EM20-006

ITB20-019

VK56 CONNECTING ROD CAP BOLT SERVICE INFORMATION

APPLIED VEHICLES: 2004-2013 QX56 (JA60/Z62)
 2014-2019 QX80 (Z62)

Figure 1

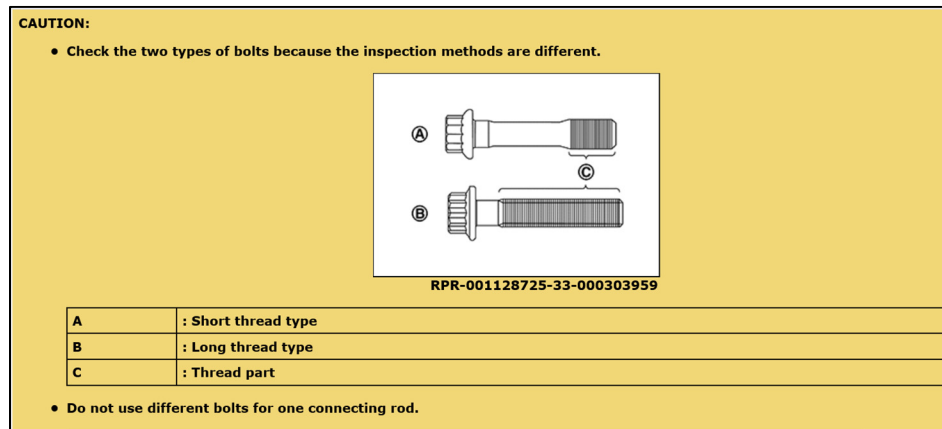
A change has been made to the connecting rod cap bolt service part. The new service part (B in Figure 1) is visually different, but is a direct replacement for the original equipment part.

If replacement of a single connecting rod cap bolt is indicated for any given connecting rod, both connecting rod cap bolts of the affected connecting rod must be replaced as a set.

Figure 2

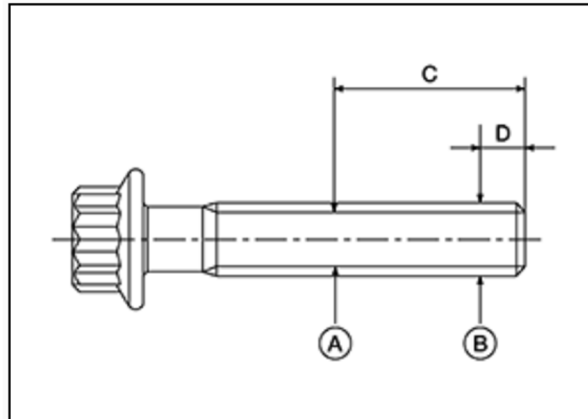
- Measure the outer diameter at location (A) and location (B) shown in Figure 2.

C	: 19 mm (0.75 in)
D	: 5 mm (0.20 in)

- Subtract (A) from (B).
Limit [(B) – (A)] : 0.15 mm (0.0059 in)
- If it exceeds the limit (large difference in dimensions), replace the bolt with a new one.
